Access Compliance Report Public Rights-of-Way (Curb Ramps)

Main Street: BRADBURY_RD Cross Street: WEATHERBY_RD Location: NW

ADA ID: RPRK211209134713 Ramp Type: Type 1 - Perpendicular Diagonal Initial Pass/Fail: Pass Overall Compliance: No Severity Score: 5

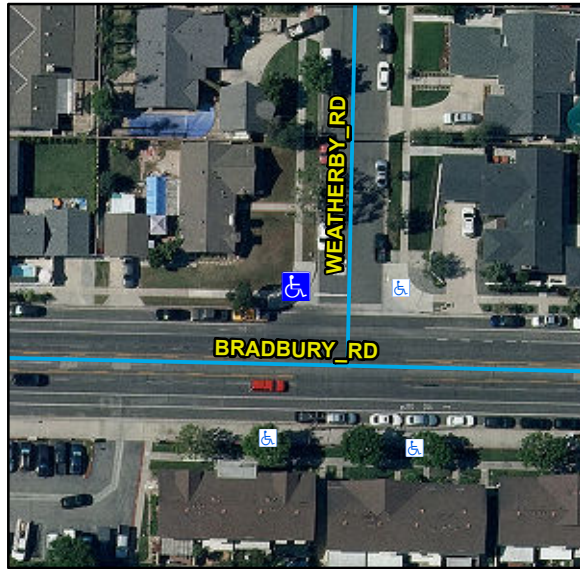
N/A	Ramp Inside Crosswalk 1	N/A	Yes	Ramp Inside Crosswalk 2	N/A
	Crossing 1 Slope (%)	6.3		Crossing 2 Slope (%)	2.9
	Crossing 1 Cross Slope (%)	2.5		Crossing 2 Cross Slope (%)	2.7
No	Gutter Ponding	Yes	No	Curb Slope	6.3
Yes	Gutter Lip Height (in)	0		Road Run Slope (%)	4.8
No	Gutter Run Slope (%)	6		Road Cross Slope (%)	0.2
No	Gutter Cross Slope (%)	3.7			
Yes	Overall Surface Condition: Acceptable		Yes	Perp Joint Present	Yes
	Cross Gutter Present?	Yes		Spandrel Present?	Yes
	Replace Cross Gutter?	No		Replace Spandrel?	No

Remove & Replace Curb Slope. Remove & Replace Gutter.
